CITY PLANNING COMMISSION

- A. Negative Declaration
- B. Tentative Subdivision Map to re-subdivide 39.2+ vacant acres in R-1A and R-2B-R zones into 237 square foot lots and one 11.5 acre lot;
- C. Special Permit to modify Special Permit (P83-334) to develop 195 patio homes in R-1A zone.

Subject: Various requests for property located NE cor. Union House
Creek and Franklin Boulevard (P84-237)

STREET ELEVATIONS

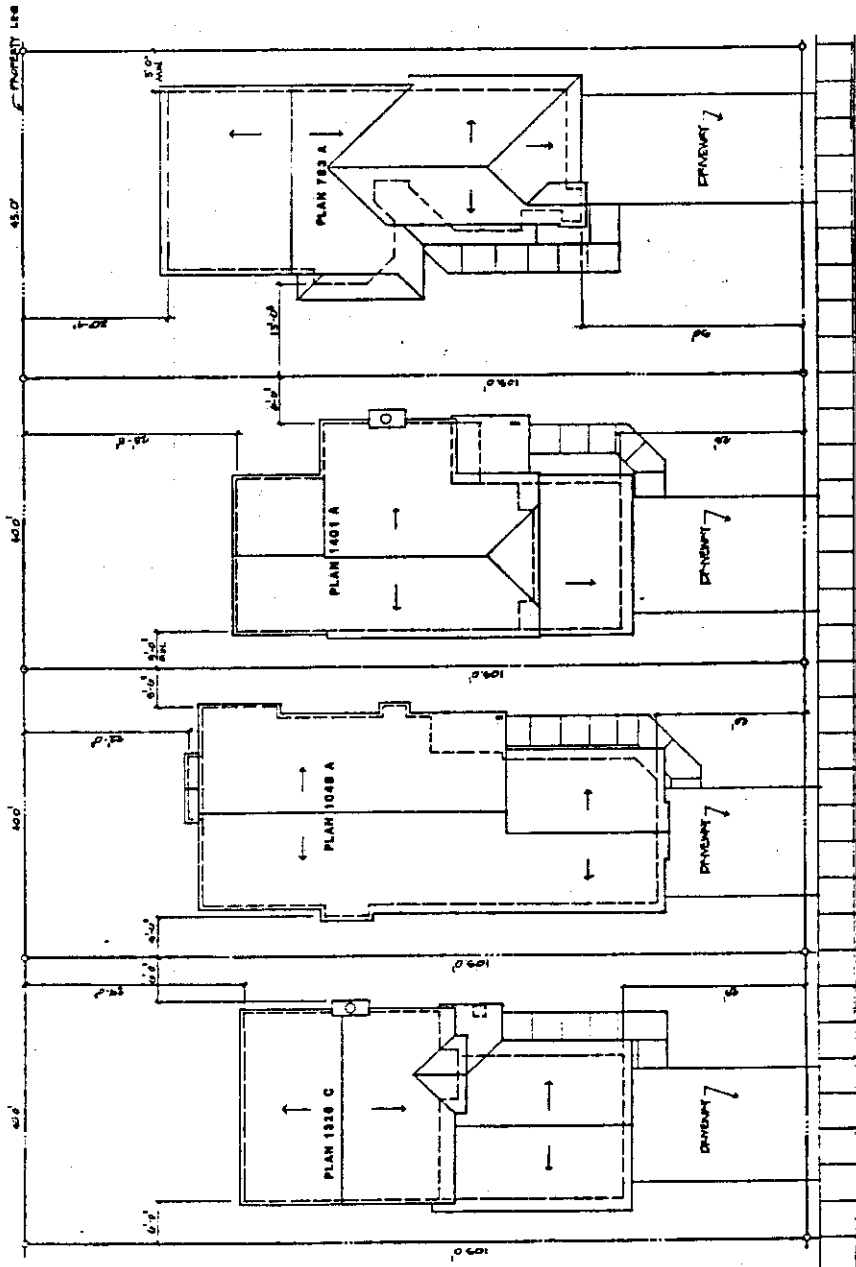
Staff has no objection to the minor revision in the number of lots being proposed. However, the elevations submitted would create streetscapes of rows of garages. Relief from this tedium can be gained by adding alternate designs such as moving the garage back, the living area forward as well as adding windows to the prime living area (kitchen and/or living room at the front of the structure. For public safety and design relief, staff recommends that at least one additional plan be provided for a greater degree of visibility. The applicant is already proposing variable front yard setbacks from 20' to 25'. This is especially useful on the two straight streets.

Staff is concerned about the presence of two story structures being built along the east portion of this project. The adjacent subdivision was approved with designs of only single story dwellings. Staff recommends that only single story structures be built on the east side of this development, which backs onto a subdivision under construction (Valley Hi Unit #18).

- a. The applicant shall submit revised plans and at least one additional plan, all of which provide for better visibility from within the units onto the street and design relief to the exterior elevation, for staff review and approval prior to the issuance of building permits;
- b. Additional exterior materials shall be used beyond the utilization of stucco and vertical wood siding. Horizontal wood siding and brick material or similar materials shall be utilized subject to staff review and approval.
- c. A variation in the front yard setback shall be utilized. In no event shall the garage be closer than 20 feet to the interior edge of the sidewalk.
- d. The applicant shall place only single story structures along the east side of the proposed development.

SITE PLAN

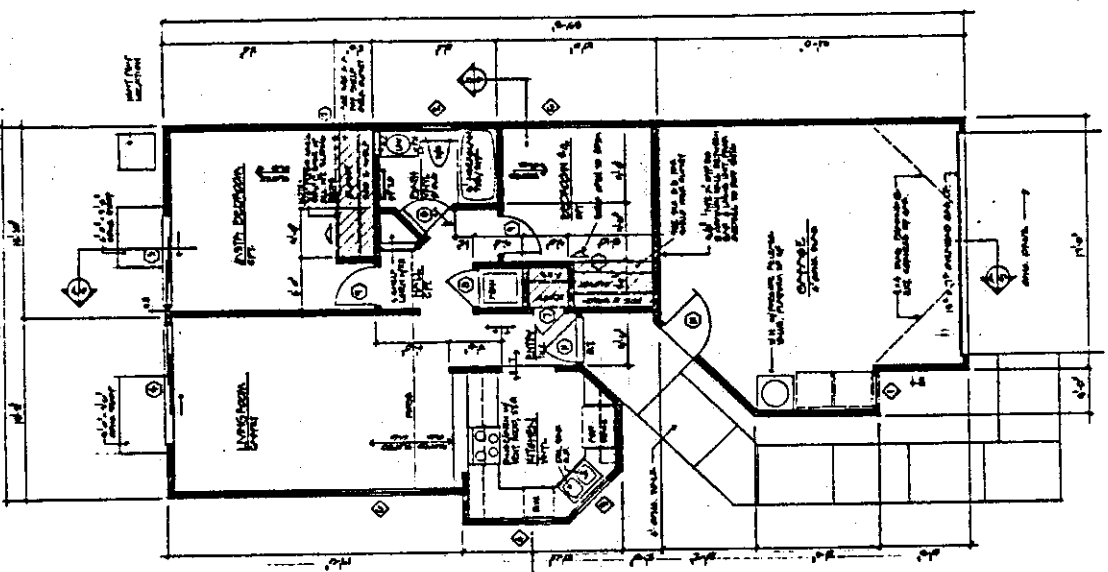
Staff is concerned about the presence of two story structures being built along the east portion of this project. The adjacent subdivision was approved with designs of only single story dwellings. Staff recommends that only single story structures be built on the east side of this development, which begins on the subdivision under construction (Valley/Hy Unit/#18).

This re-subdivision is a slight change from what was approved by Council on November 10, 1983 (See Exhibit 1). Various corner lots have been reoriented and/or divided into two lots instead of a duplex lot. Halfplexes and zero lot line patio homes have been changed to single family detached patio homes.

For Phase II on the 14 lots behind Goodwin Circle, the applicant shall reduce the two-story/one story ratio from 1:1 to 1:2 and place a minimum backyard depth of 30 feet on lots which will have two-story homes.
